Service Bulletin No: 53-012
Modification No: Inspection

FUSELAGE - GENERAL

DO A CHECK OF THE MATERIAL SPECIFICATION USED IN THE MANUFACTURE OF THE ENGINE MOUNT FITTINGS AND, IF NECESSARY, DO A CHECK FOR CRACKS WITH A BOROSCOPE

Check of the Material Specification
Figure 1

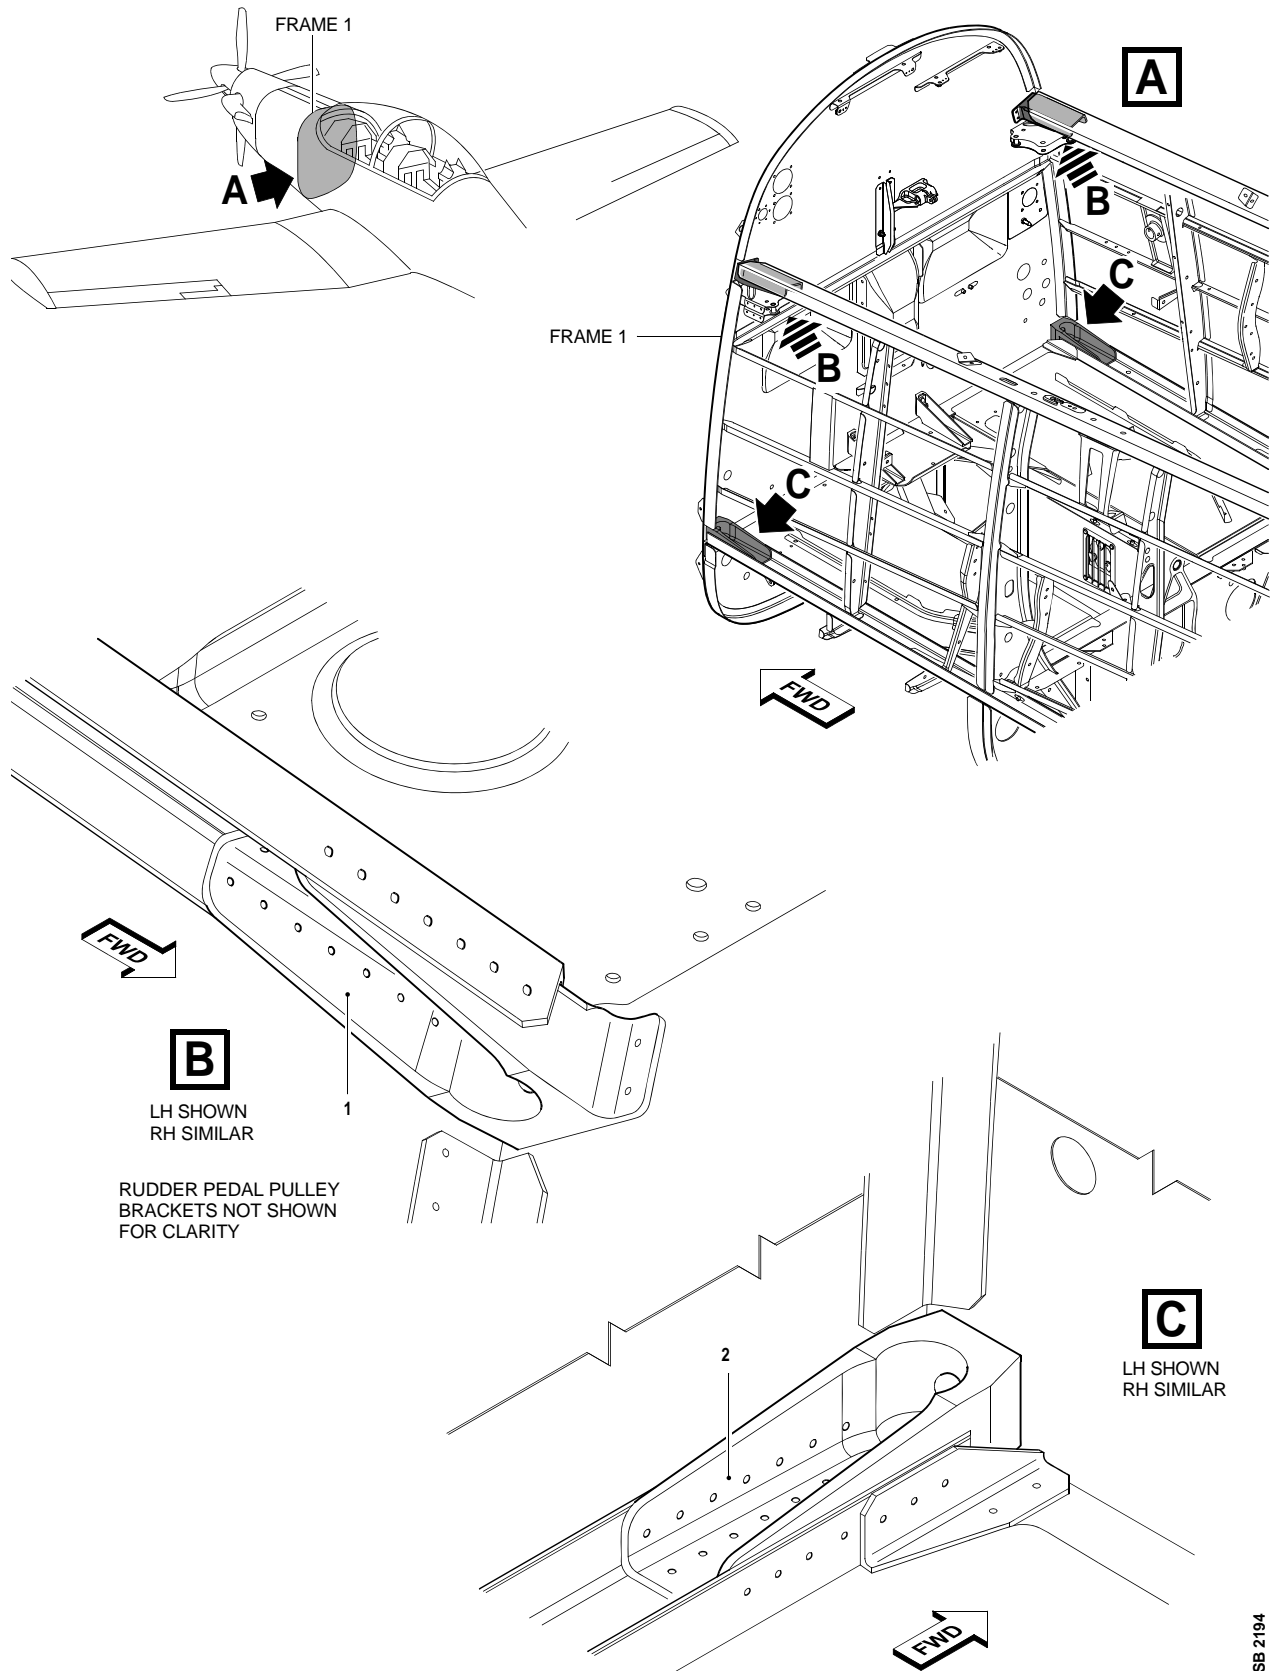
B. Do the Test to Find the Material Specification (Ref. Fig. 1)

- (b) Put the eddy current probe in position on the left upper engine-mount attachment-fitting (1) (P/N 553.10.09.123).
 - (c) Record the value shown on the test equipment.

- (d) Compare the value recorded above with the values recorded in Section 3.A.(5) and determine if the attachment fitting is manufactured from AA2024-T351 or AA2124-T851.

Fittings - Crack Inspection (If Necessary)
Figure 2

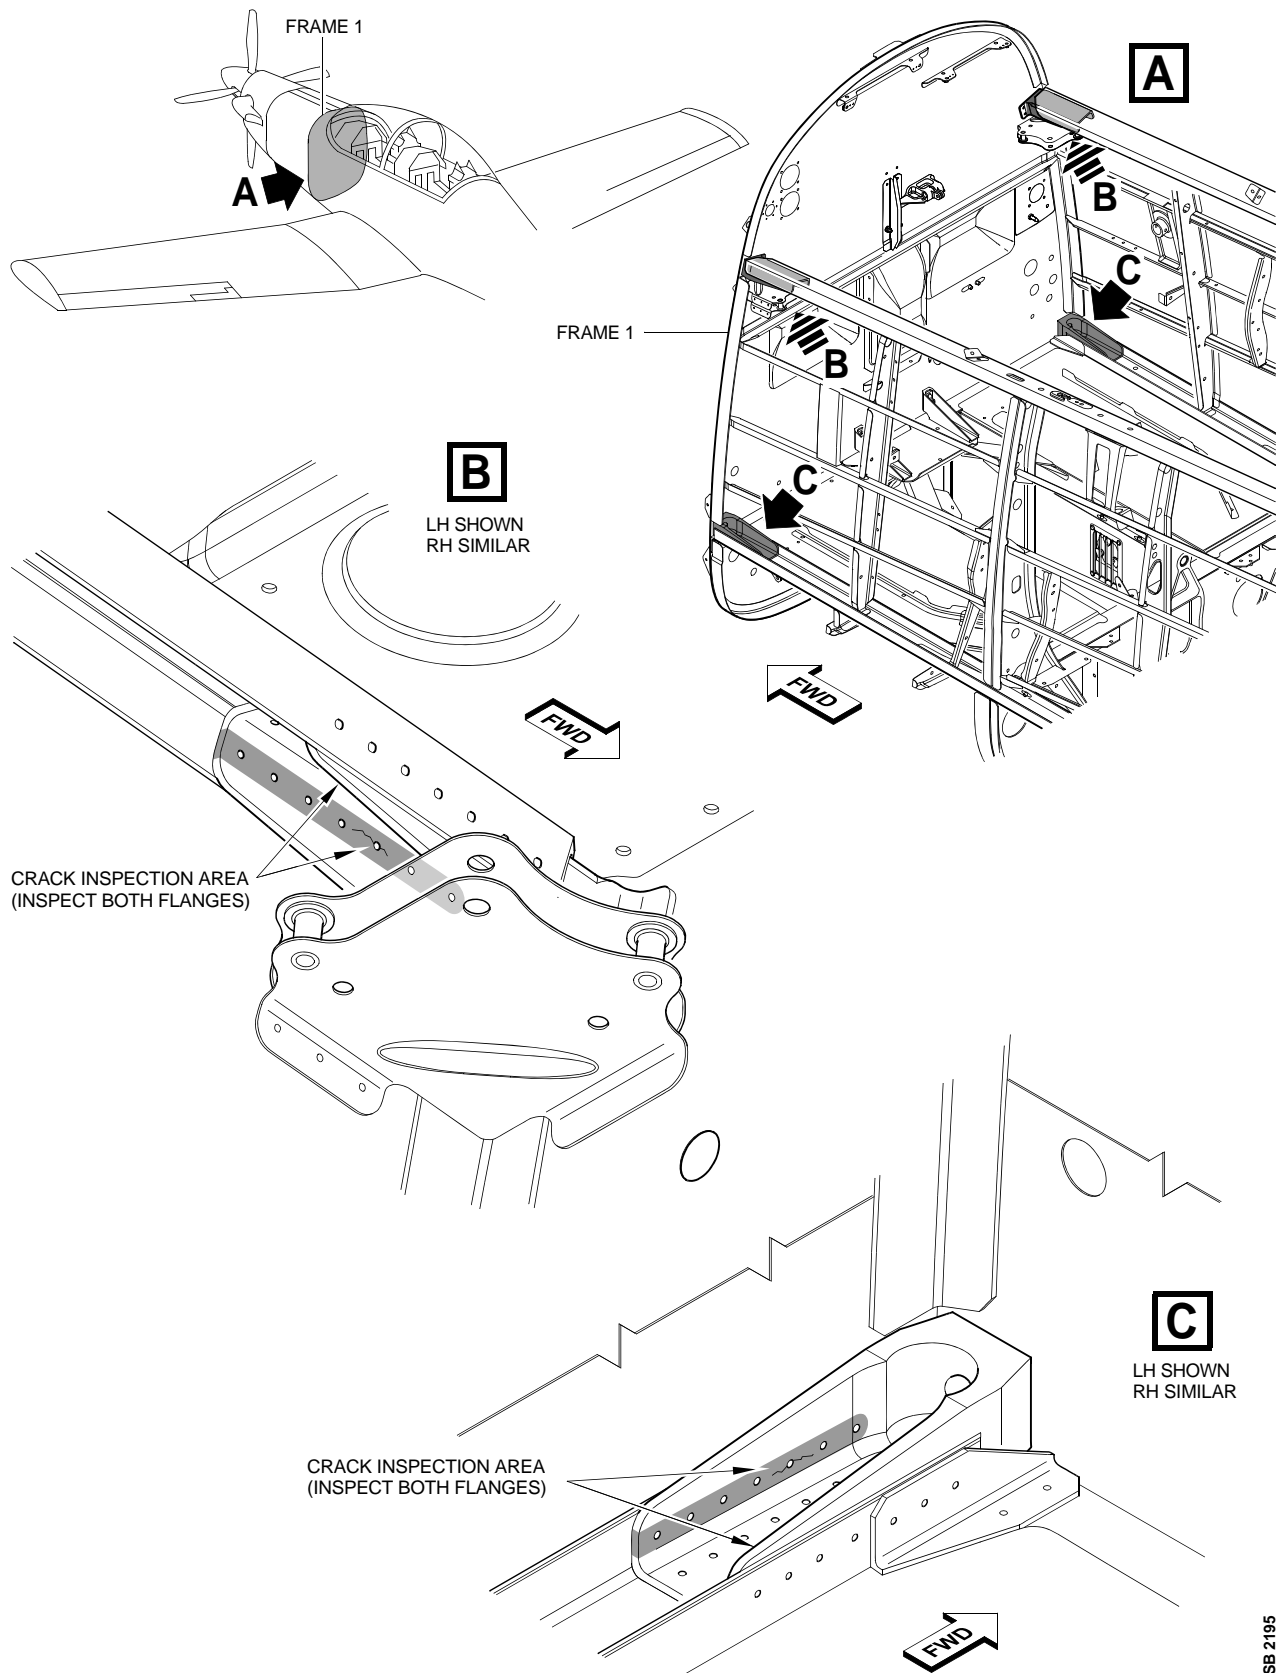
C. Do the Boroscope Inspection to Find Cracks (Ref. Fig. 2)

- (1) Obey the manufacturer's instructions and use a boroscope to examine the areas shown in Fig. 2:
- (a) Use the aluminium or steel tube as a guide for the boroscope to access the inspection areas.
 - (b) If you find cracks:
 - 1 You must contact Pilatus Customer Support before next flight. The address is:
